## URBAN DESIGN PANEL

## RESPONSE TO URBAN DESIGN PANEL COMMENTS \_ ENTRANCE LOBBIES

**Re: Proposed Hotel, cnr Cambridge Terrace and Worcester Boulevard.**

RESPONSE TO URBAN DESIGN PANEL COMMENTS \_ HARLEY FACADE RETENTION OPTION A

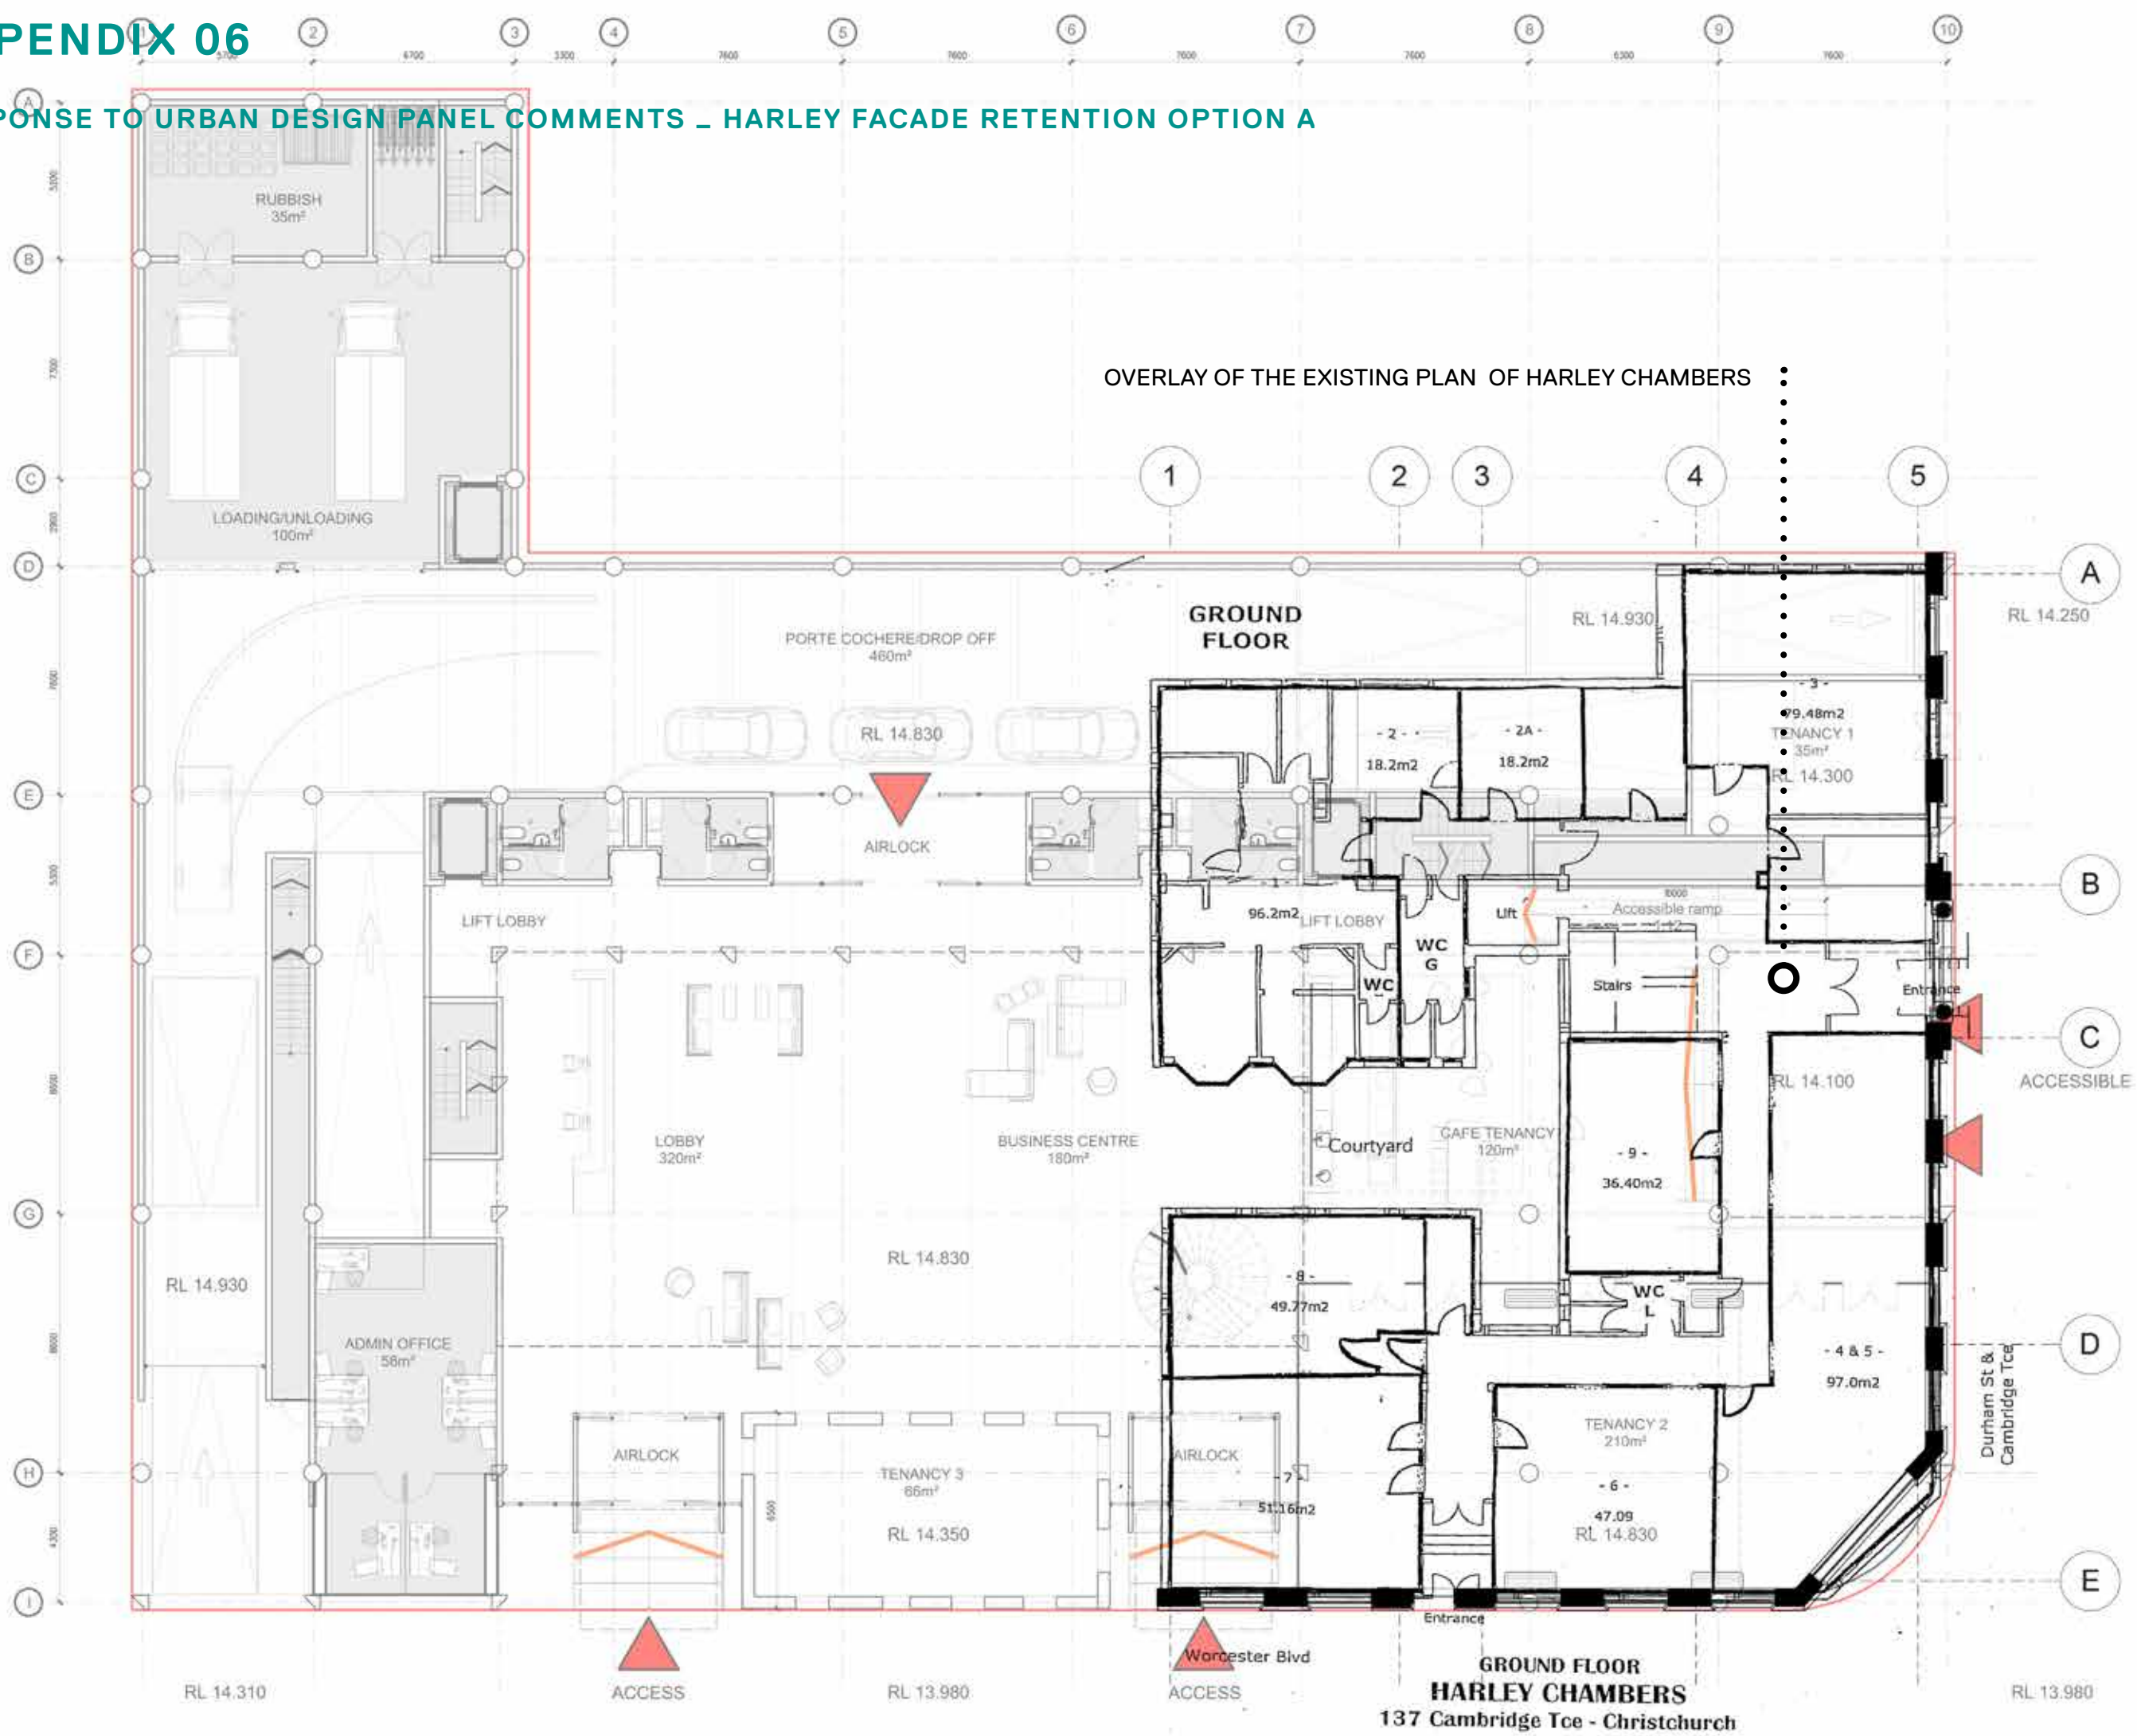
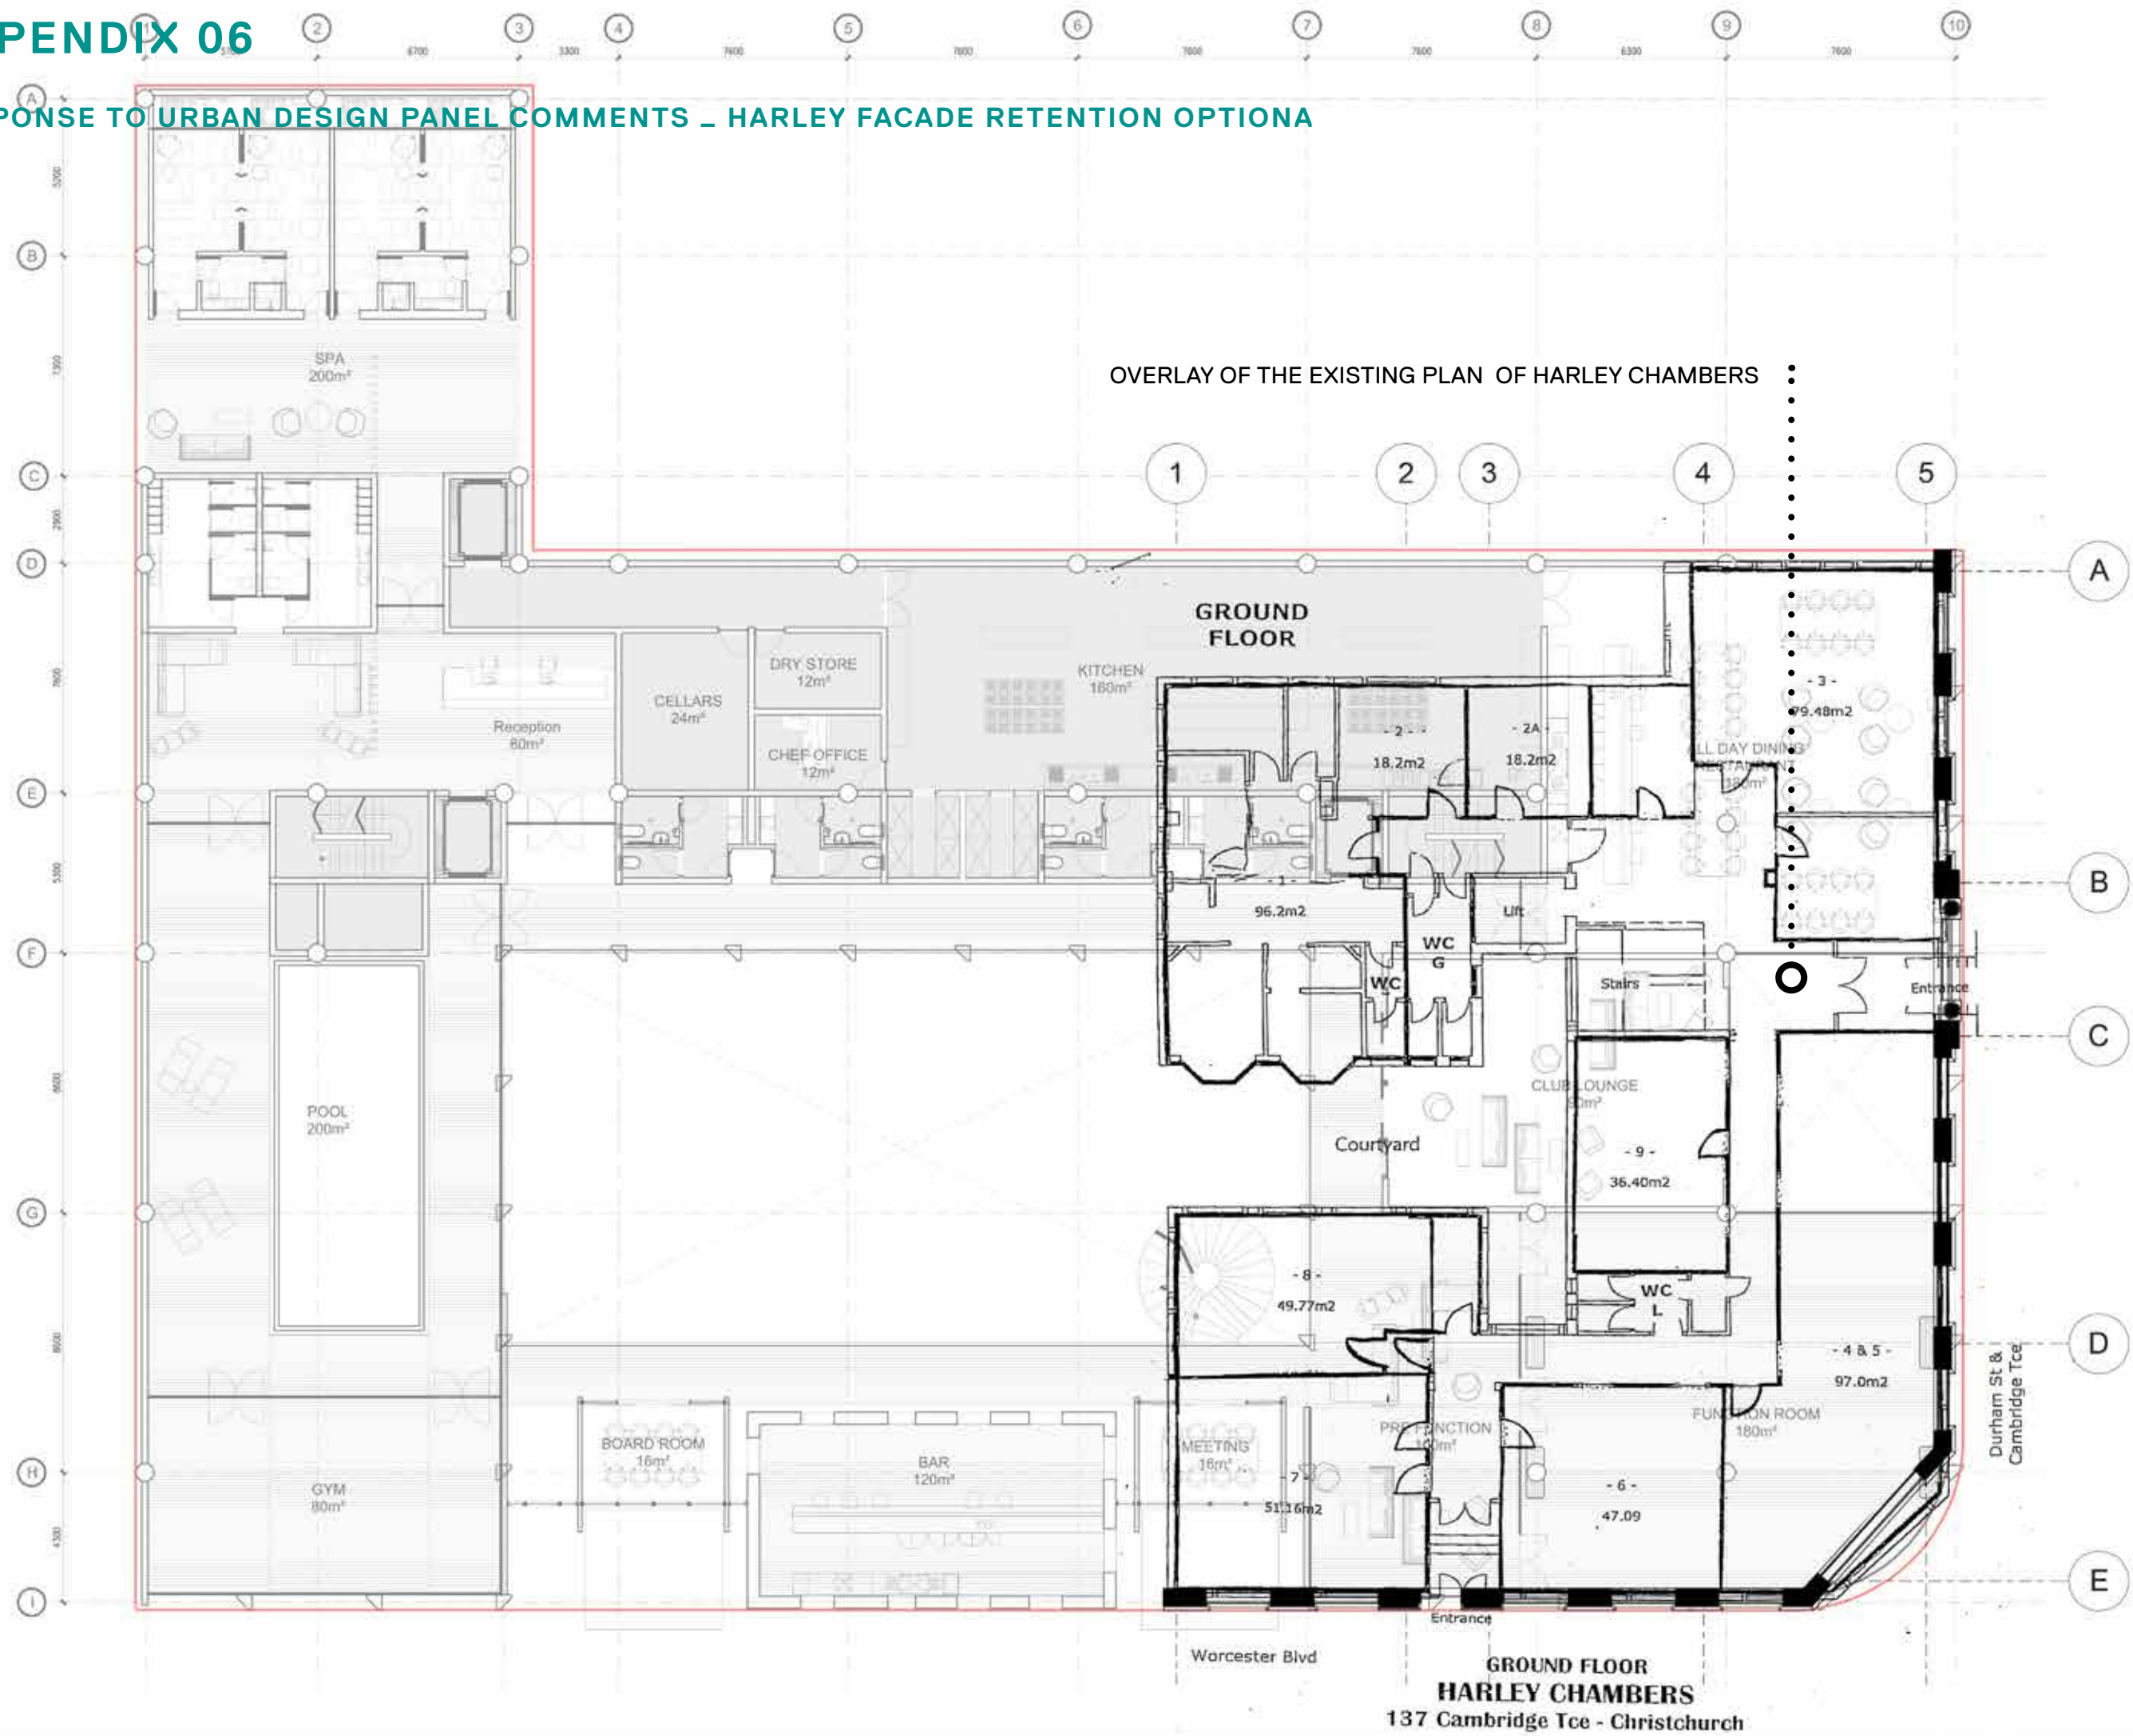
2. Considers that the corner treatment to the proposal needs further resolution to strengthen the relationship to the key axes and to this important pedestrian corner. Agreed
3. Acknowledge that a robust argument for the demolition of Harley Chambers will be required.

As the overlay drawing enclosed indicates, the idea of using the overall building is unlikely to be successful given the imperative to provide a certain number of rooms on the site.

If the floor layout was derived from the existing building layout, including the window/pier column relationship a number of rooms per floor would be lost from the layout.

A secondary concern would be that the floor to floor heights do not support the scale of rooms or difference in room scale required in the hotel design. The implied floor to floor heights are in the order of 3.5 m which are too small for the new structure and services which will be required.
